Memorandum

To: City of Berkeley Landmarks Preservation Commission
From: Rhoades Planning Group
Date: June 30, 2015
Re: 2211 Harold Way – July 9, 2015 Landmarks Preservation Commission
Response to LPC Comments on June 4, 2015

The purpose of this memo is to describe the materials provided for the July 9, 2015 Landmarks Preservation Commission meeting in response to comments that the project team received from the Commission at its June 4, 2015, meeting. These materials are supplemental to the complete plan set submitted to the Commission for its June 4 meeting.

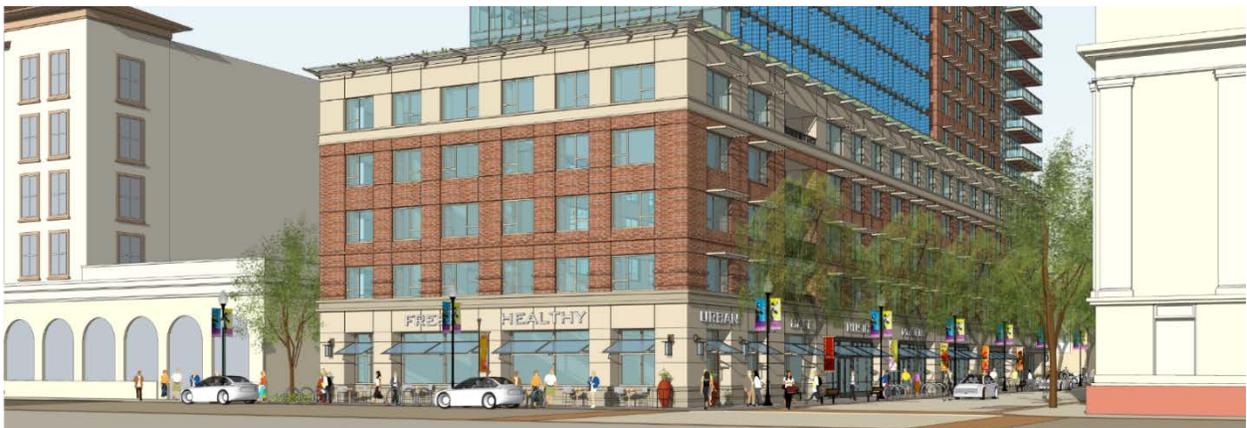
13. Cinemas as a Community Benefit. Commissioners requested additional information on the proposed movie theaters as a significant additional community benefit, specifically about whether or not the space would remain available for community use in perpetuity. Commissioners also requested additional information about the locations of the cinemas (i.e., if they are below grade, explain how they will maintain aesthetic quality).

Response: The movie theaters are proposed to be rebuilt as a Significant Additional Community Benefit
